## **MICHELE ESTATES SUBDIVISION**

APPLICATION NUMBER 10 DATE April 20, 2006

APPLICANT Michele Subdivision

REQUEST Subdivision

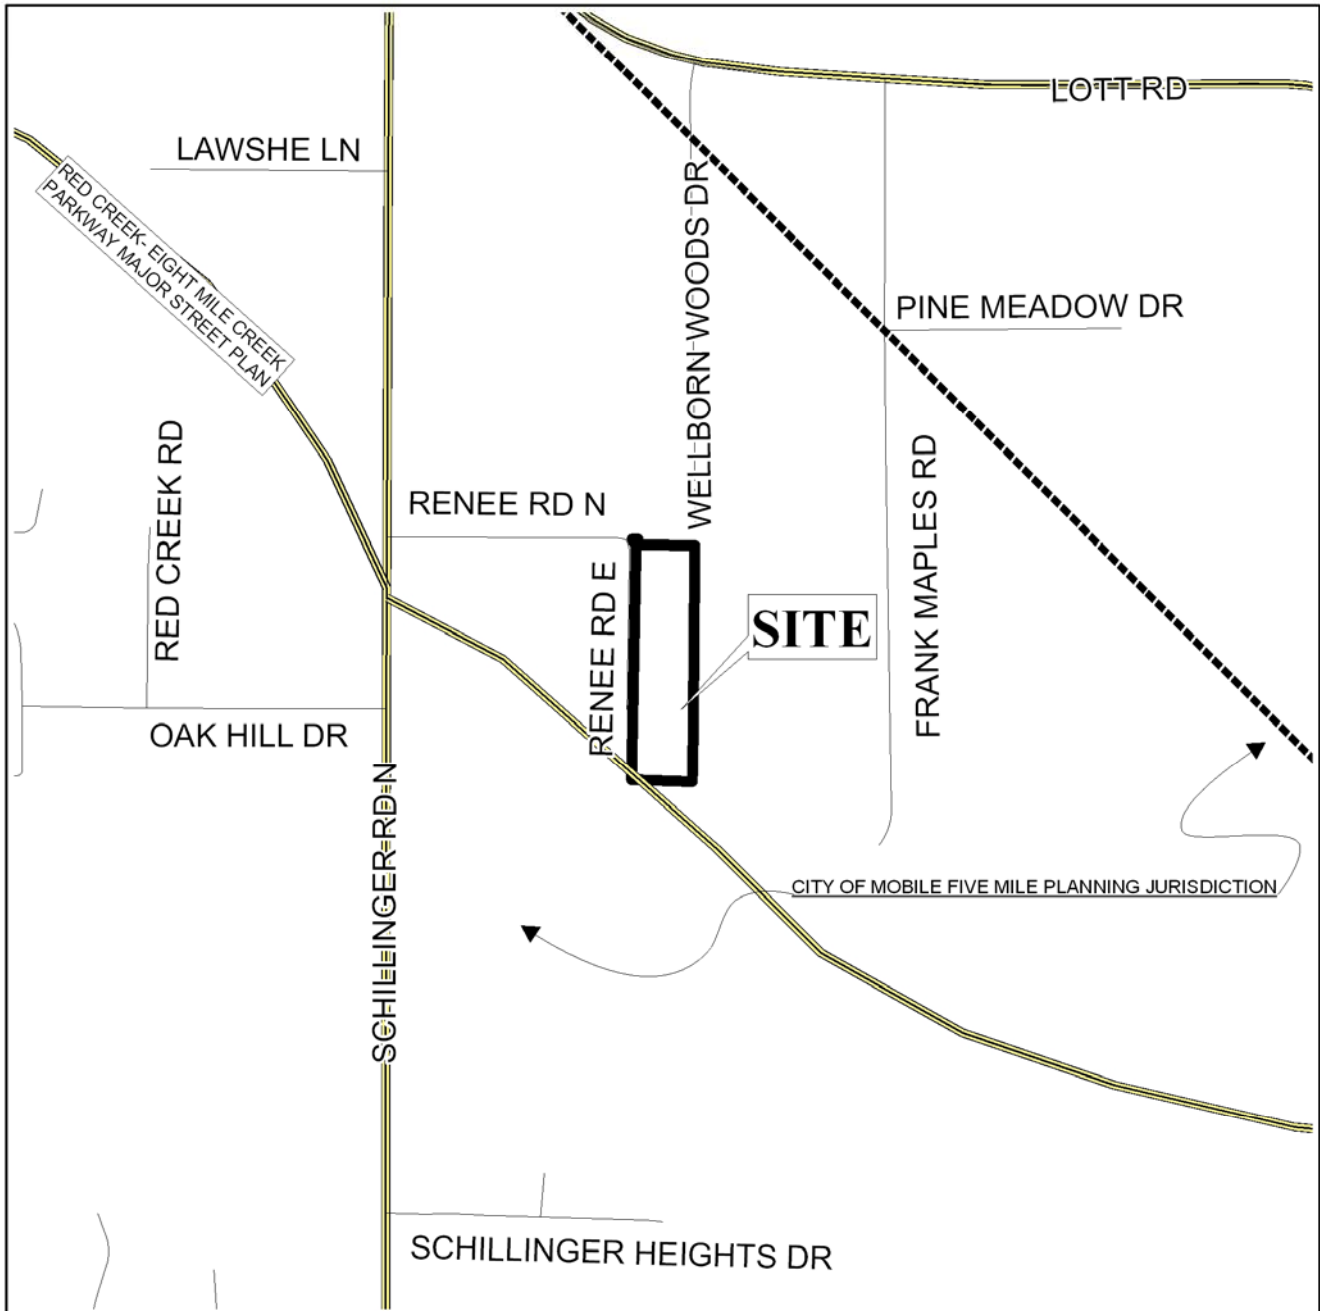
Engineering Comments: Must comply with the Mobile County Flood Damage Prevention Ordinance.

The site fronts Renee Road East, a County-maintained dirt road with an apparent right-of-way of 30 feet, which is substandard. As such, dedication of sufficient right-of-way to provide 25 feet from the centerline of Renee Road East should be required, and a note should be placed on the final plat stating that there will be no future resubdivision of the property until Renee Road East is improved to County Engineering standards. The 25-foot building setbacks are not shown and would be required on the final plat.

The site appears to lie within the general path of Red Creek-Eight Mile Creek Parkway, a planned major street; however, the depiction on the Major Street Plan Map is for a general corridor. Therefore, the exact location of the proposed major street is largely unknown. Additionally, the parkway is not shown on the Mobile Area Transportation Study 2030 plan.

Because the exact location of the major street is unknown, dedication or setback would not be possible or practical. Therefore, a note should be placed on the final plat stating that the site appears to be in the path of the proposed major street, and thus may be impacted by the major street in the future.

The site is located in the County; thus any lots that are developed commercially and adjoin residentially developed property must provide a buffer, in compliance with Section V.A.7 of the Subdivision Regulations.

The plat meets the minimum requirements of the Subdivision Regulations and is recommended for Tentative Approval, subject to the following conditions: 1) dedication of sufficient right-of-way to provide 25 feet from the centerline of Renee Road East; 2) the placement of a note on the final plat stating that there will be no resubdivision of the site until Renee Road East is improved to County Engineering standards; 3) the placement of a note on the final plat stating that the site appears to be in the path of the proposed major street, and thus may be impacted by the major street in the future; and 4) the placement of a note on the final plat stating that any lots that are developed commercially and adjoin residentially developed property must provide a buffer, in compliance with Section V.A.7 of the Subdivision Regulations.
